- Subject: Calvert Cliffs Nuclear Power Plant
Units Nos. 1 & 2; Dockets Nos. 50-317 and 50-318
Main Steam Line Break Inside Containment
- References: (a) NRC I&E Bulletin 80-04, Main Steam Line Break With
Continued Feedwater Addition, dated February 8,
1980.
- (b) NRC Letter from R. A. Clark to A. E. Lundvall,
dated January 20, 1982.
- (c) BG&E Letter from A. E. Lundvall to R. A. Clark,
dated November 16, 1982.
- (d) BG&E Letter from A. E. Lundvall to R. A. Clark,
Sixth Cycle License Application, dated February 17,
1982.

RESPONSE TO NRC QUESTIONS*

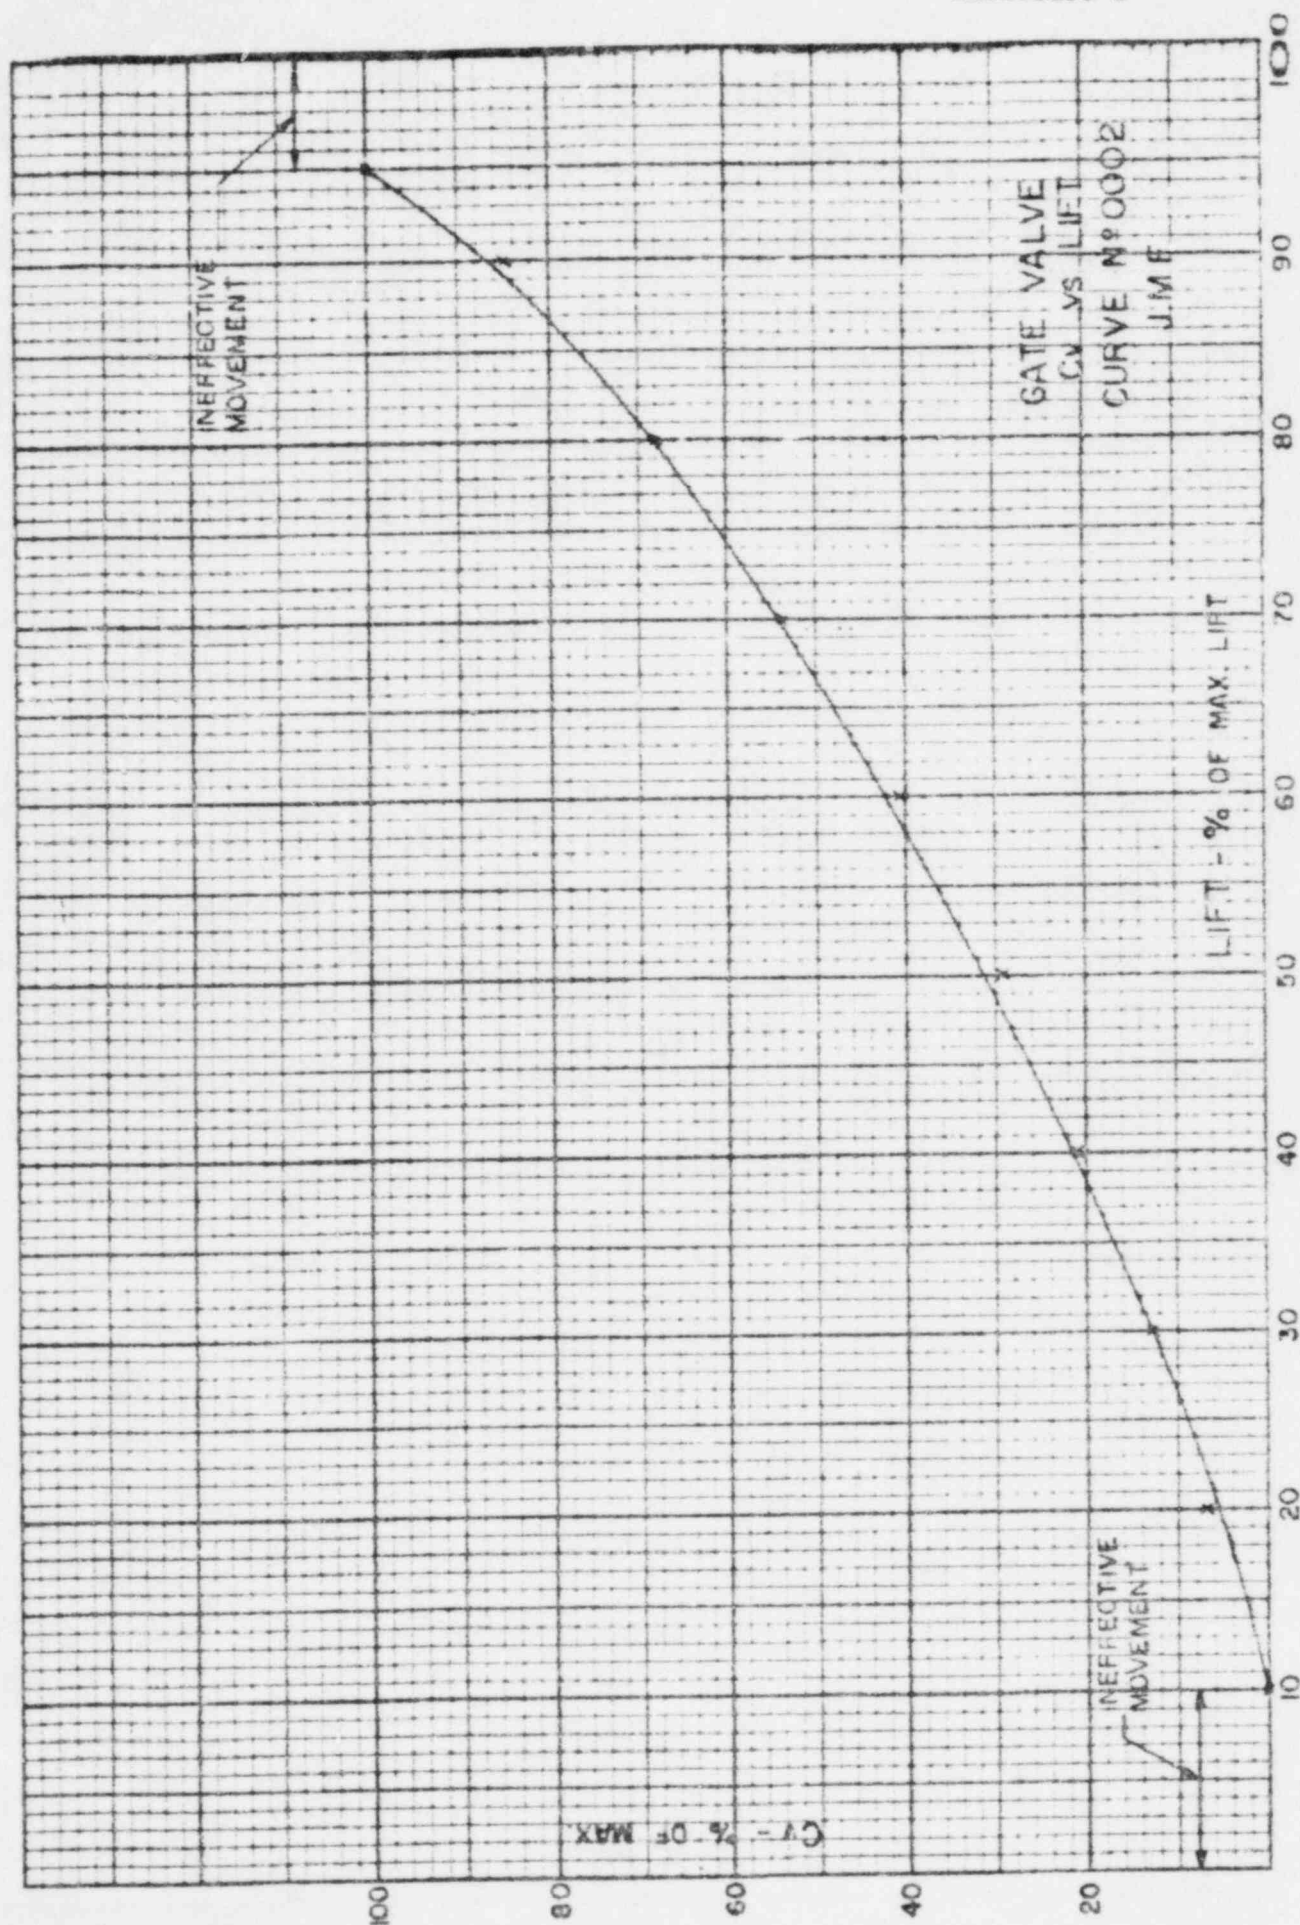
3. What are the Main Feedwater Isolation Valve (MFIV) flow characteristics?

According to the valve manufacturer (Velan), the flow characteristics of the MFIV are closely represented by the attached Cv versus lift curve.
